# Access Compliance Report

## Public Rights-of-Way

Intersection ID: N/A	Main Street: MORRISON_BV	Cross Street: SOUTH_PARK_DR	Location: NW
ADA ID: 6188121244FF	Ramp Type: Perp	Initial Pass/Fail: Fail	Overall Compliance: No
Severity Score: 22.5			
Codes/Mitigation Info/Possible Solution		Field Measurements/Component Compliance

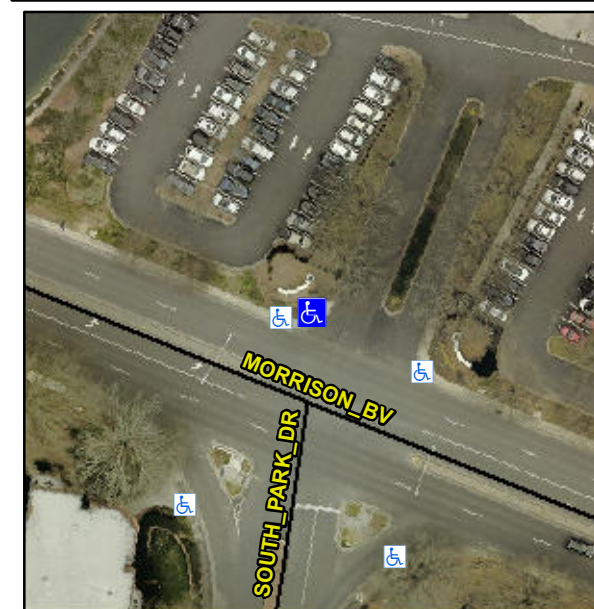
**Not Found, R304.5.1, R304.2.2, R304.5.3**

Compliance	Description	Data	Compliance	Description	Data
N/A	Ramp Length (in)	48.0	No	Ramp Slope (%)	9.5
No	Ramp Width (in)	47.0	No	Ramp XSlope (%)	3.8
N/A	Flare Type LT	N/A	N/A	Flare Type RT	N/A
N/A	Flare Slope LT (%)	N/A	N/A	Flare Slope RT (%)	N/A
N/A	Flare Traversable LT?	N/A	N/A	Flare Traversable RT?	N/A
N/A	Landing Length (in)	N/A	N/A	DWS Provided?	N/A
N/A	Landing Width (in)	N/A	N/A	DWS Contrast?	N/A
N/A	Landing Slope (%)	N/A	N/A	DWS Length (in)	N/A
N/A	Landing X Slope (%)	N/A	N/A	DWS Full Width?	N/A
N/A	Landing Curb? (Y/N)	N/A	N/A	DWS Offset (in)	N/A
N/A	Shared Landing?	N/A			
N/A	Gutter Ponding?	N/A	N/A	Gutter Slope (%)	N/A
N/A	Gutter Lip Ht (in)	N/A	N/A	Gutter X Slope (%)	N/A
N/A	Painted X Walk1?	No	N/A	Painted X Walk2?	N/A
	X Walk 1 Direction	To E		X Walk 2 Direction	N/A
N/A	X Walk 1 Width (in)	N/A	N/A	X Walk 2 Width (in)	N/A
	X Walk 1 Slope (%)	6.0		X Walk 2 Slope (%)	N/A
	X Walk 1 X Slope (%)	1.6		X Walk 2 X Slope (%)	N/A

**Remove & Replace Entire Ramp.**
